Revised Change Order

Re: Repair to Press box

PROJECT NAME Bellevue - Gilligan Stadium Pressbox

SUBJECT **Structural Modifications**

PRESS BOX SITE PLAN

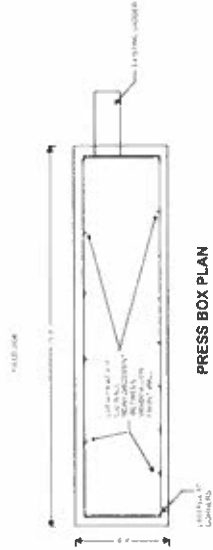
-I measured the amount of rotation the press box has experienced due to foundation settlement prior to grout install. The west wall has rotated up to 4 1/2" at the top of wall. Not as much, but similar on the east wall. Calculating this eccentricity and the effect on the unreinforced cmu wall suggests that the wall can take the dead and live vertical load from the roof of the press box, but does not have enough capacity to take any horizontal (wind) load.

-Due to the eccentricity of the wall loads, the corners need to be tied together with steel angles and the front and back walls need vertical angles added to take the wind load. A strap will also need added to the end walls to help with stability.

-I could not access the interior of the space, but understand the floor slab has significant slope, similar to the rotation of walls. This will need leveled with a concrete grout, or potentially a wood sleeper system with plywood flooring-all weather treated, whichever is cheaper and easier.

-I was not able to access the roof structure. It appears to have a hard ceiling, thus some demolition will be required to gain access. I will need to measure depth and spacing of members and check for adequacy and condition. At a minimum, the roof rafters will need to be anchored to the bearing walls with steel angle and anchorage.

See attached drawing for plan layout and details for modifications.
